Board of Zoning Adjustment
Staff Report
 May 7, 2018

Case No:	18VARIANCE1035
Project Name:	Big Bar Expansion
Location:	1202 Bardstown Road
Owner(s):	Chris Cook Holdings LLC
Applicant:	Kevin Bryan
Jurisdiction:	Louisville Metro
Council District:	8 – Brandon Coan
Case Manager:	Dante St. Germain, Planner I

3. Site Plan

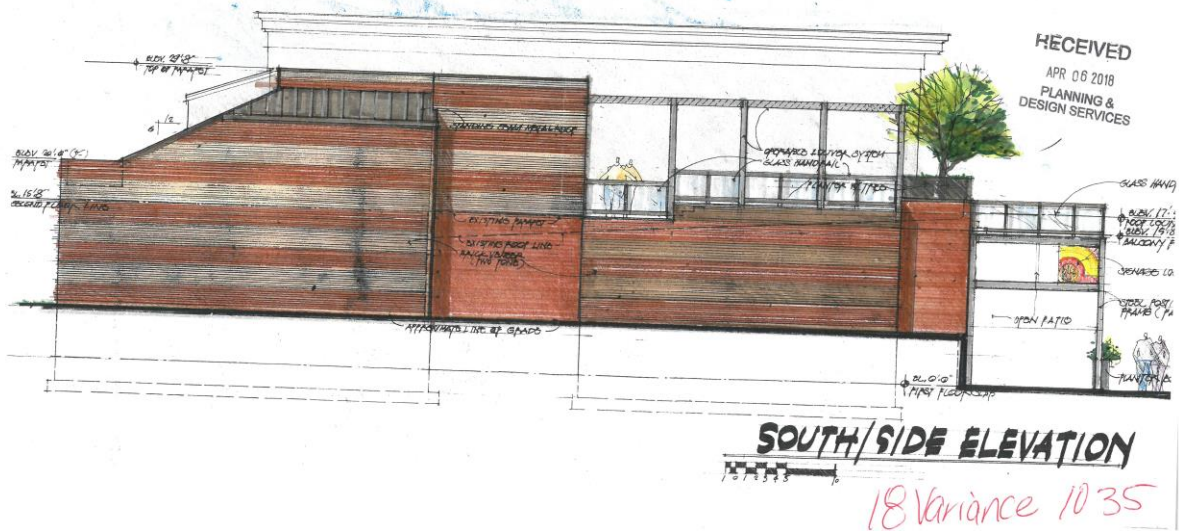
The subject property is located in the Tyler Park neighborhood and in the Bardstown Road Overlay District, along the west side of Bardstown Road near the intersection with Lucia Avenue. The property currently contains a one-story commercial structure, which does not extend to the rear of the property. The applicant proposes to renovate the existing structure, with one aspect of the renovation extending the structure to the rear property line to provide accessible restrooms and an emergency egress stair, which will encroach into the rear yard setback.

There is no alley access to the lot. The rear property line abuts a multi-family residential use. Currently, the rear yard of the property is a grassy, overgrown area above grade which is shared with the property to the north. The lot is approximately 17 ½ feet wide in the front and approximately 11 ½ feet wide in the rear.

STAFF: The requested variance will not allow an unreasonable circumvention of the zoning regulations as the lot is unusually narrow with a correspondingly narrow structure, creating a situation in which the only ways to expand are vertically and to the rear.
